FORM APPROVED
OMB NO. 1004-0135
Expires: July 31, 2010**SUNDRY NOTICES AND REPORTS ON WELLS** MAR 14 2016
Do not use this form for proposals to drill or to re-enter an abandoned well. Use form 3160-3 (APD) for such proposals.

CHEVRON U.S.A. INC. INTENDS TO RECOMPLETE THE SUBJECT WELL FROM THE N. SHUGART MORROW TO THE WOLFCAMP RESERVOIR.

Lease Name: Baish Federal
 Well No. 12
 Location: 990' FNL & 1650' FWL
 Sec.: 9
 Twn 18 S
 Rnge 31 E
 Cost Center

API No.: 30-015-31376
 Current/Proposed: Proposed
 Spud Date: 11/20/2000
 Comp. Date: 1/6/2001
 County: Eddy
 State: New Mexico

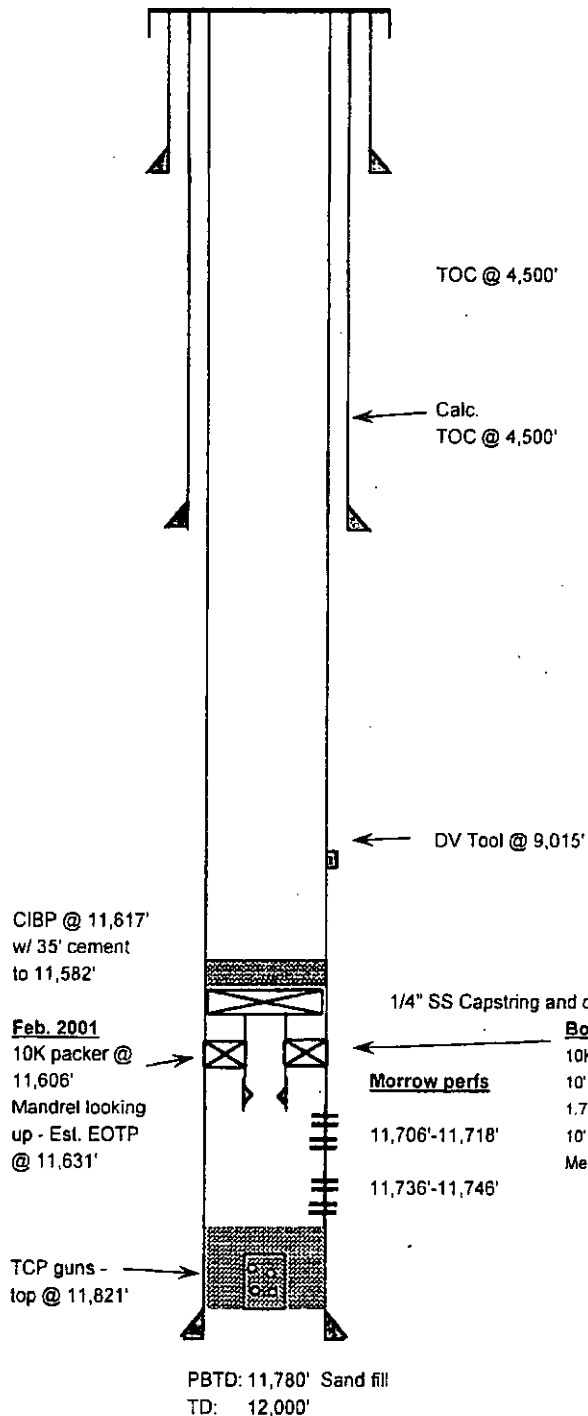
Set CIBP @ approx. 9664' & dump 35' of cmt on top.

Proposed Wolfcamp Perforations
 9207-9211, 9224-9230, 9287-9297, 9300-9312,
 and 9317-9321' @ 4 spf, 90 deg phasing
 Porposed CIBP @ 9664' w 35' CMT on top

In lieu of a cement plug across perforations in a cased hole (not for any other plugs), a bridge plug set within 50 feet to 100 feet above the perforations shall be capped with 25 sacks of cement.

Before pumping cement on top of CIBP, tag will be required to verify depth. Based on depth, a tag of the cement may be deemed necessary.

Unless otherwise specified in the approved procedure, the cement plug shall consist of either **Neat Class "C"**, for up to 7,500 feet of depth or **Neat Class "H"**, for deeper than 7,500 feet plugs.
